Normandy Action Group Objection to Planning Application 25/P/01726

We object to this application on the following grounds:

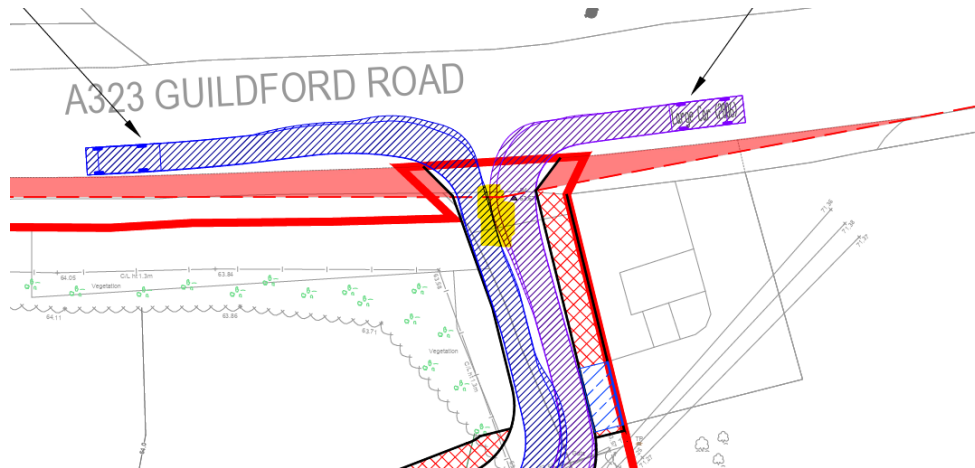
- a. It is too far away from all parts of the main site to be readily accessible on foot: at its closest it is 800 metres away, but it is at least 2 kms to the extremity of the main site. Because of the distance, the SPA is closer and more convenient to get to from Glaziers Lane than the SANG.

- b. In addition, the pedestrian access routes are notoriously user-unfriendly, and frequently waterlogged, especially in winter.
- c. The site has a convoluted shape and lacks coherence and spatial integrity. At the northern end it is located close to a busy main road, the A323 (which would become a lot busier if this application went ahead), and in the middle it is adjacent to the housing estate at Wyke Avenue. It looks like a choice of last resort for the developer, given the limited availability of land in the vicinity. As natural greenspace, it hardly compares with the Ranges, which would therefore attract many if not most of the additional walkers – and their dogs. It certainly does not constitute “*attractive green space for recreation*” as per the Planning Statement.

- e. It is actually closer to the SPA than is the main site. It is also closer to the housing developments in Ash, which would therefore provide competition for its use and make it less attractive to the inhabitants of the new development.
